Lower Merion

July 23, 2019

**RE: Township Zoning Code Update  
Draft 3.0 dated July 19, 2019  
Building Height for Institutions (school buildings)**

**HARRITON HIGH SCHOOL**  
**Drawing A3.11**  
**Building Sections 4 and 5**

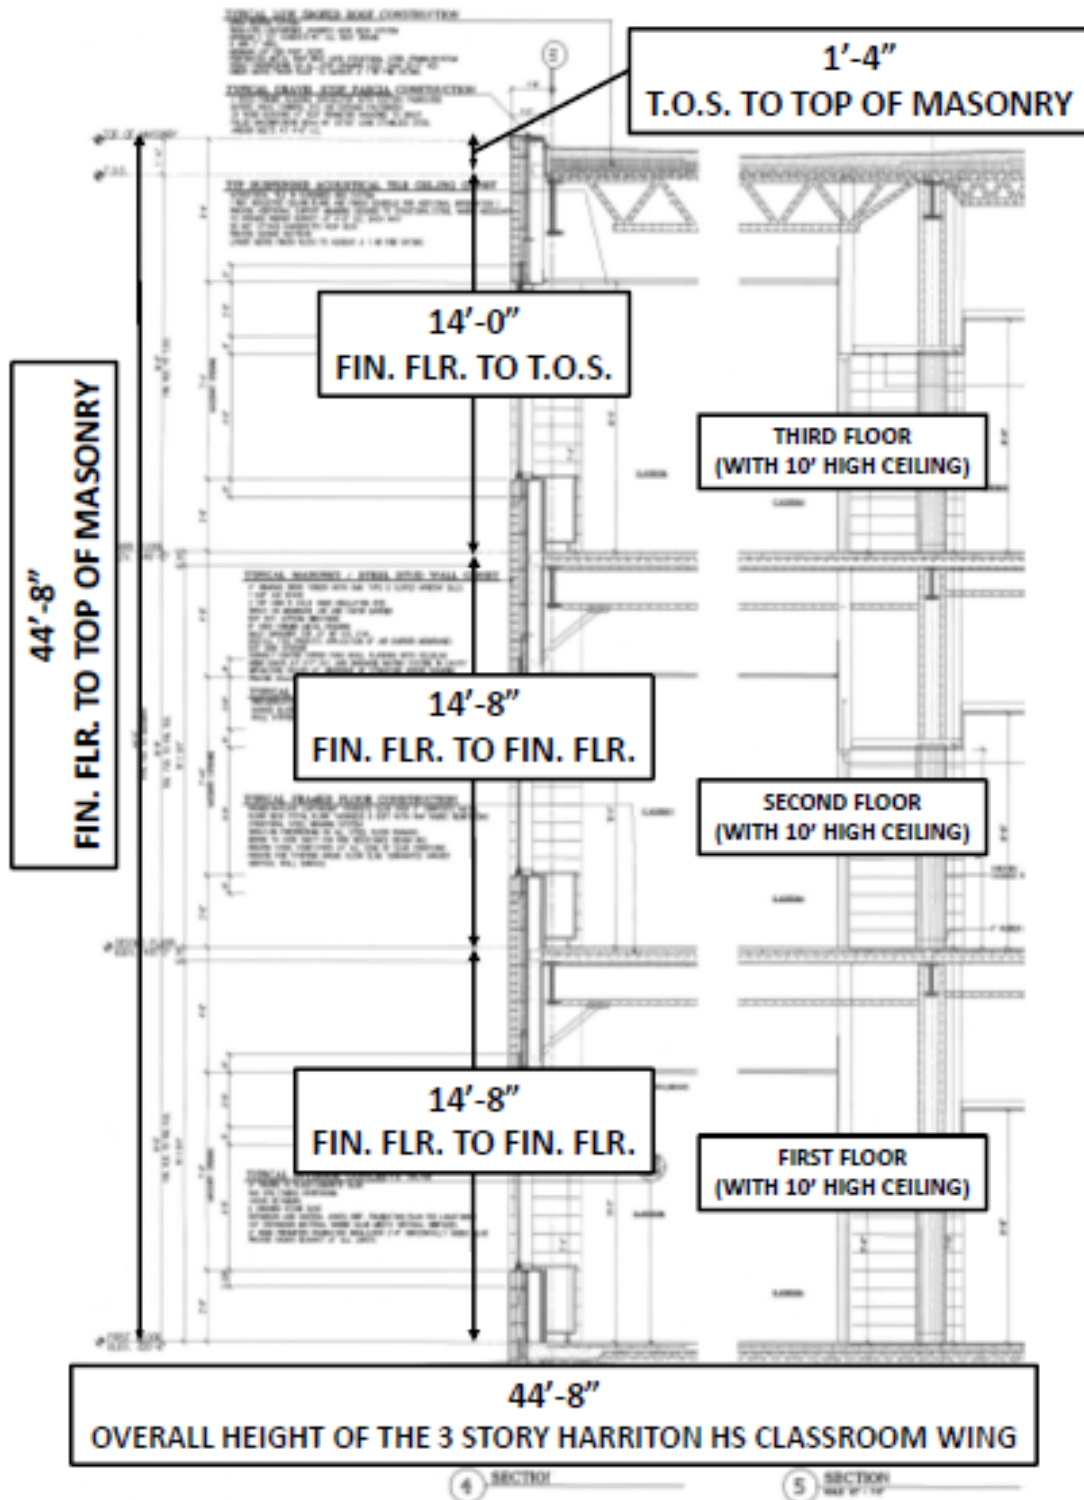
School buildings are typically designed with a finished floor to finished floor height of approximately 14' - 8". This is based on the following:

- Acoustical ceiling grid and tiles at an elevation 10' - 0" above finished floor
- Approximately 2' - 8" between the acoustical tile ceiling and the bottom of the structural steel for the floor above. The volume between the acoustical tile ceiling and the bottom of the building structure is used primarily for heating, ventilation, and air-conditioning (HVAC) distribution ductwork. Code requirements for fresh air (ventilation) in school buildings are dramatically higher than residences and significantly high than office buildings. This requires large ducts to be installed between the ceiling and the building structure
- The building structural steel (horizontal members) and elevated concrete slabs on metal decks require approximately 2' - 0" in height.

As shown in the attached examples (Harriton High School, Lower Merion High School and the proposed New Middle School at 1860 W. Montgomery Avenue), a 3 story school with a low-sloped (“flat”) roof will typically be 44’ - 0” to 45’ - 0” tall.
